COMBUSTION PROBLEMS IN  
ORR AND SEMBOWER INCORPORATED  
800 lbs/hr AUXILIARY BOILER  
(MSO CLASS)

NBTL Project B-471  
Final Report

8 February 1963

Encl: (1) NBTL SK. #A588 of final burner-air nozzle modification

FINAL MODIFICATION TO BURNER-AIR NOZZLE  
ORR & SEMBOWSKI AUXILIARY NOZZLE (MSO-CLASS)

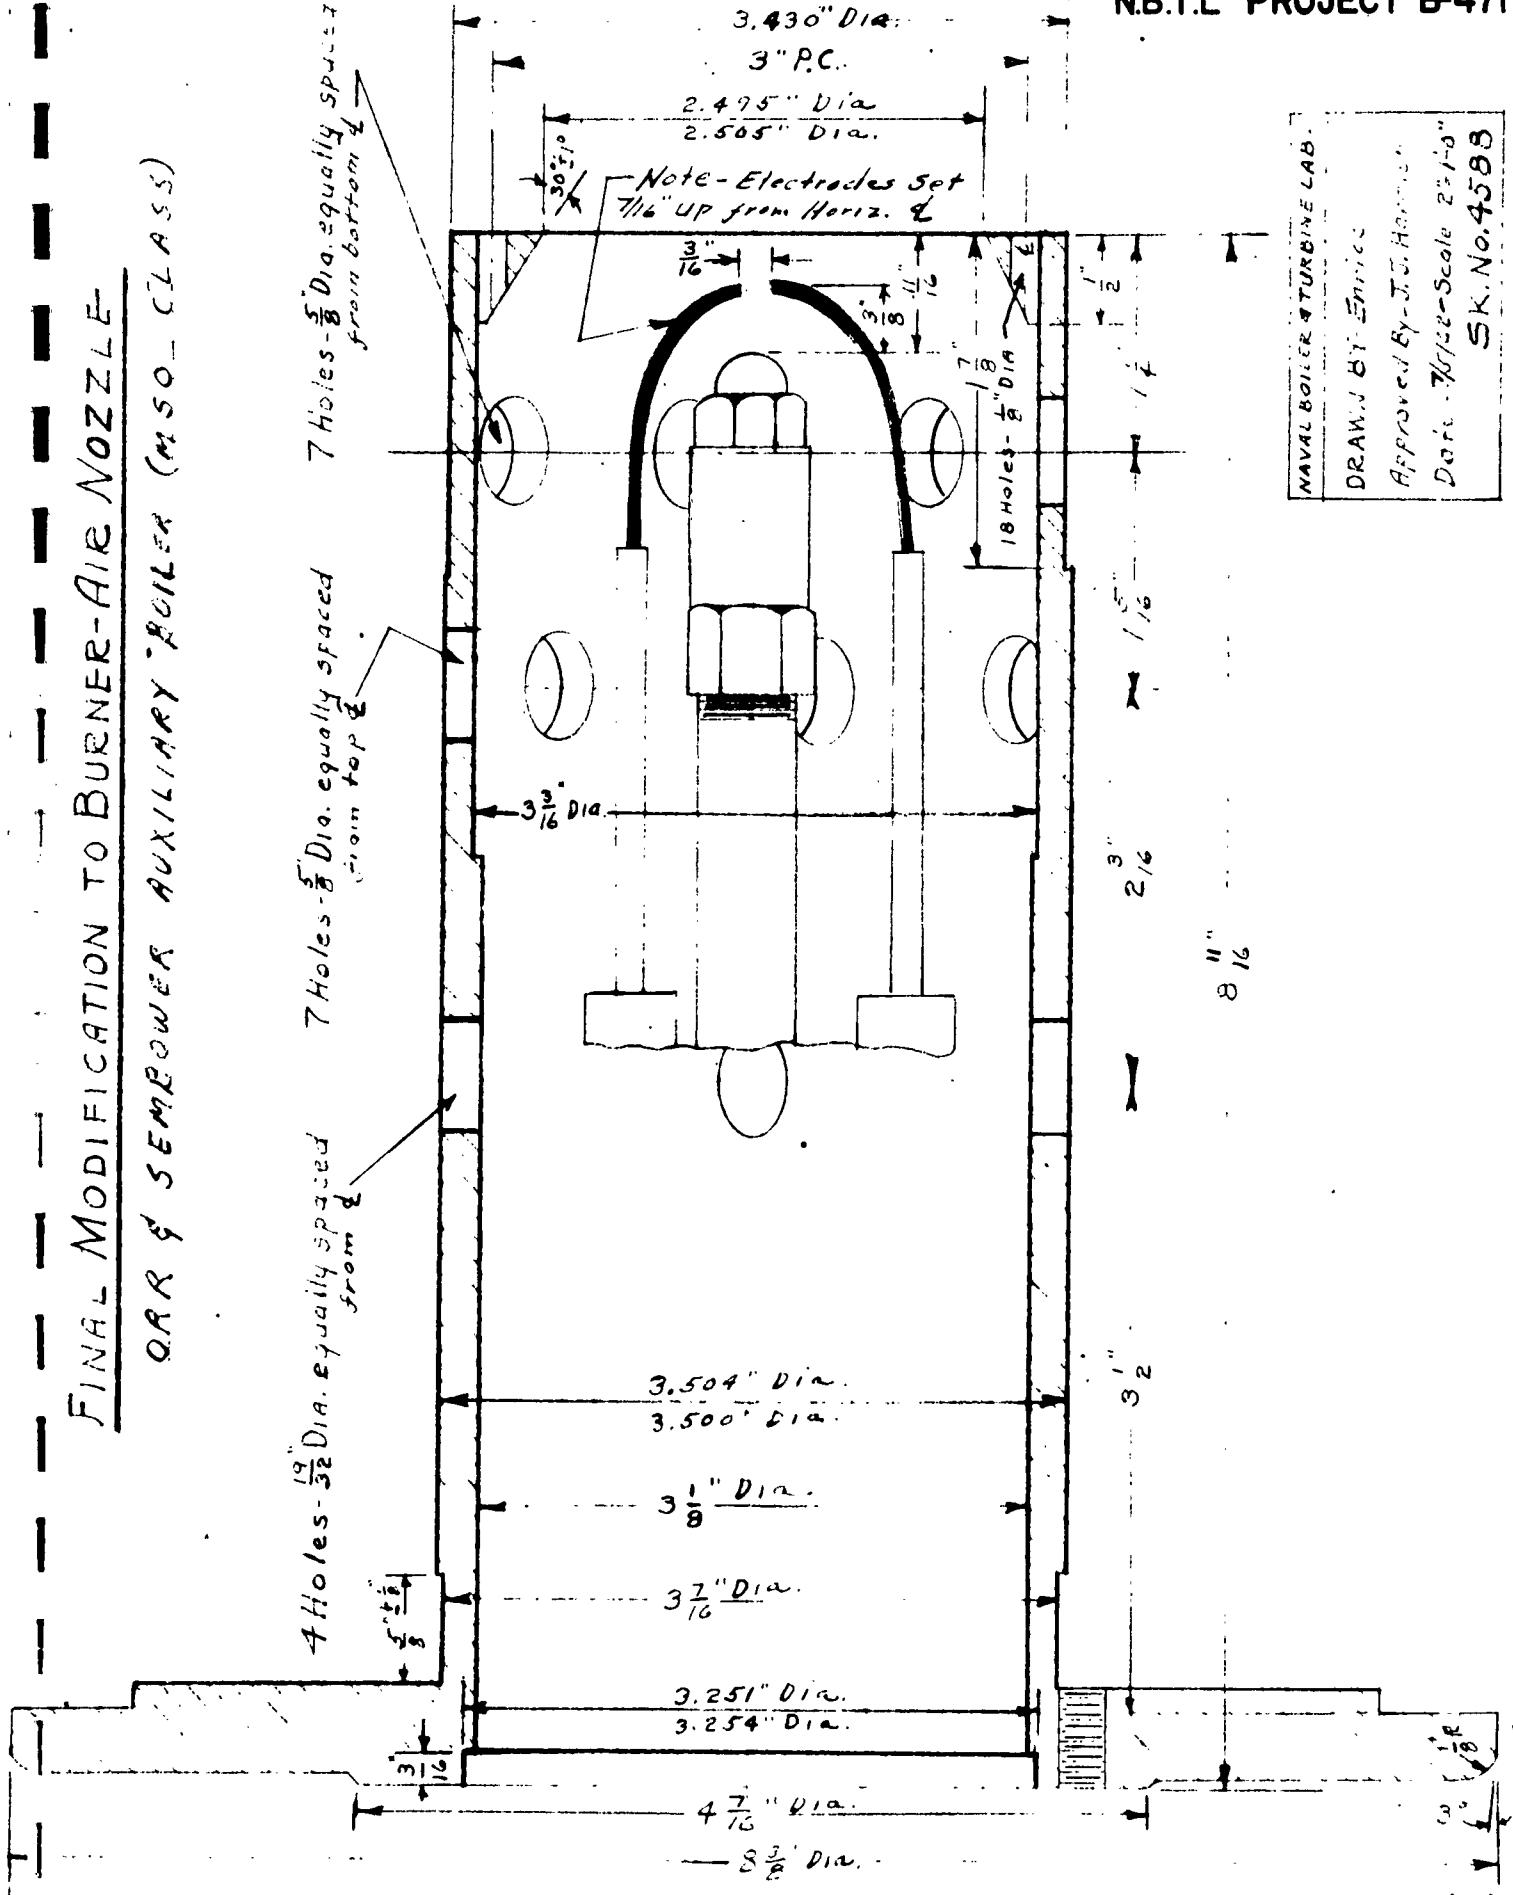
- 7. It is recommended that burner modifications be made on each boiler of the subject type now in service so that all units will agree with enclosure (1). The burner as shown in enclosure (1) differs from that shown in reference (c) as follows:

- a. The first inlet row of 1/2 inch holes in the burner air nozzle has been eliminated.
  - b. The original second inlet row becomes the first row and is made up of four 19/32 inch diameter holes instead of seven 5/8 inch holes.

- c. The outside diameter of the burner air nozzle exit end is reduced 0.010 inches to 3.430 inches.
  - d. The burner oil tube is 3/16 of an inch longer making the distance between sprayer plate and end of nozzle 11/16 of an inch.

- e. Ignition electrodes were set 7/16 of an inch from horizontal center line of burner tip edge.

In addition, drawings should be changed as well as technical manuals to assure proper burner arrangement and, therefore, improve combustion performance in the future.
